**Appendix A
NRC3-09-0012**

**Attachment 1
NRC3-09-0012**

Response to RAI letter related to Fermi 3 ER

RAI Question GE1.1-1

**Fermi 3 General Site Audit Handouts
(following 2 pages)**

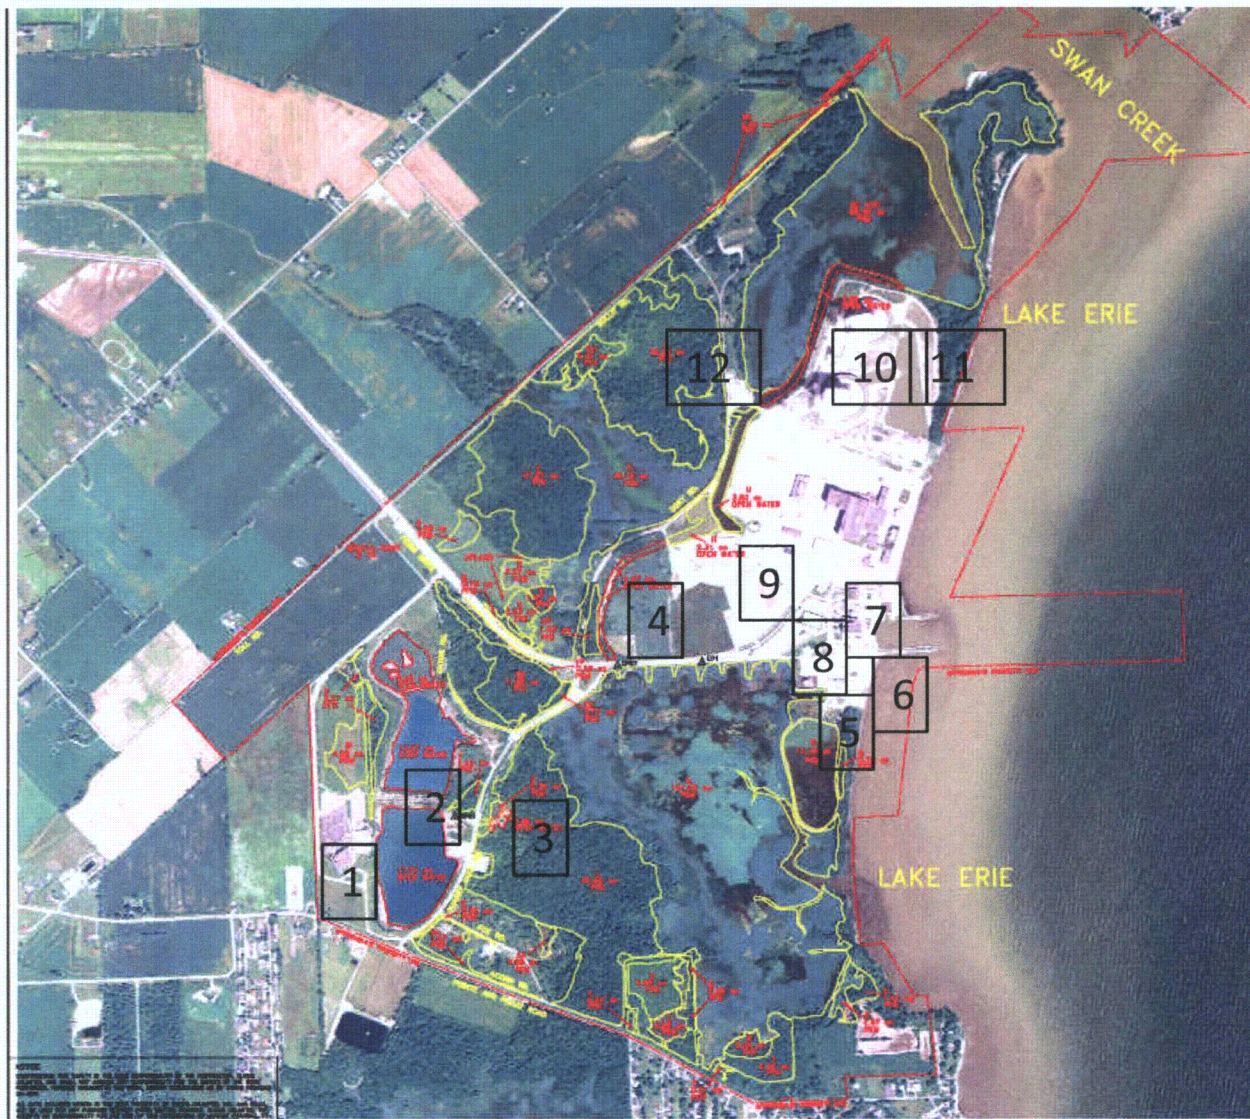
Provide copies of handouts used during the Fermi 3 general site audit tour.

During the environmental audit held February 2 through February 6, 2009 a general site tour was conducted and handouts were provided to help describe the site and orient the participants. A copy of the handout used to support this tour has been provided. Note that the handout identifies point 3 on the map as "Cooling Tower Location" and point 4 on the map as "Proposed Cooling Tower Location"; the location indicated by point 4 now reflects the cooling tower's location in the revised configuration.

**Figure – DTE Fermi Site
(following 1 page)**

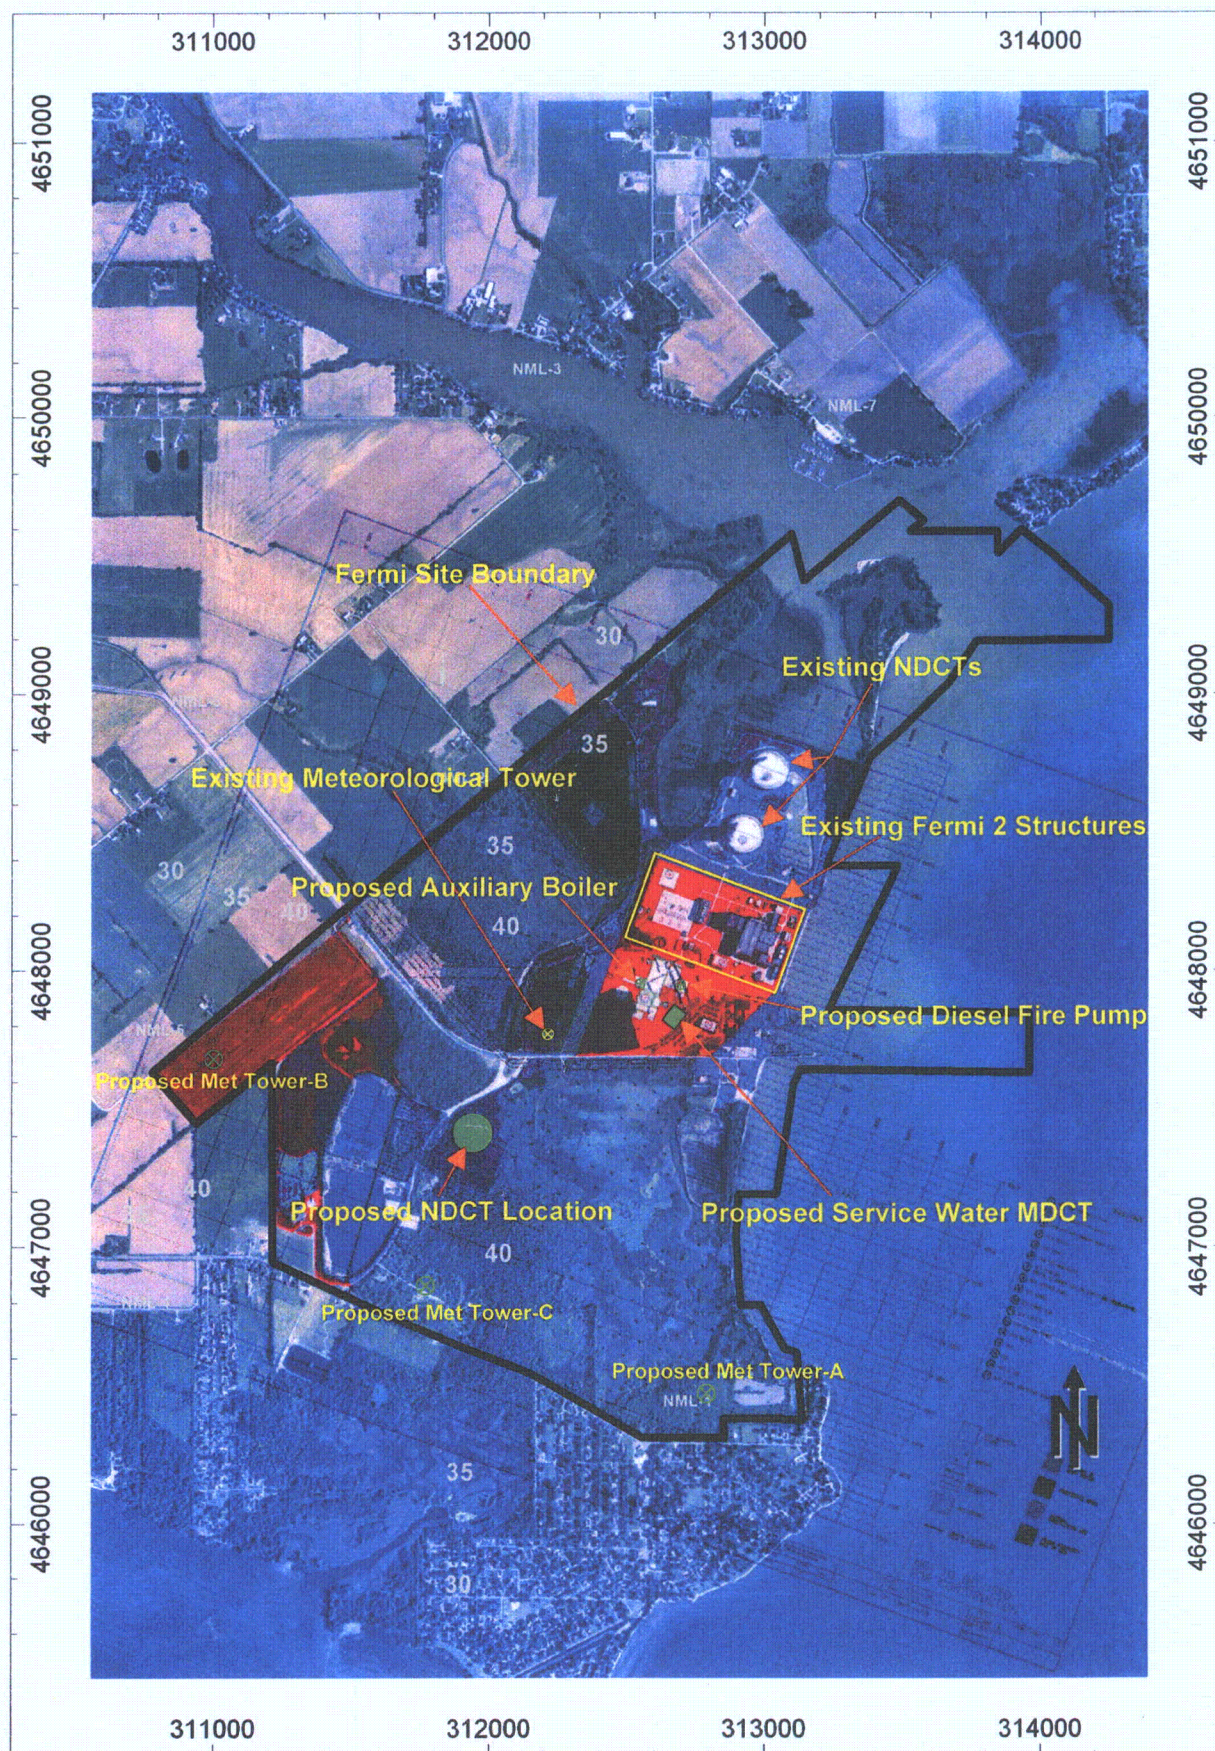
Provide a copy of the figure used during the air quality/meteorology tour (titled "DTE Fermi Site") that included locations of existing and proposed air emission sources.

A figure titled "DTE Fermi Site" was utilized during the environmental audit held February 2 through February 6, 2009 to show the approximate locations of the existing and proposed emissions sources for the Fermi site as they were known at the time of the audit. A copy of this figure has been provided in this transmittal.

Since the audit, relevant changes to air emissions sources have been made which this figure does not reflect: the natural draft cooling tower has been relocated, and two ancillary diesel powered generators have been added to the plant configuration.
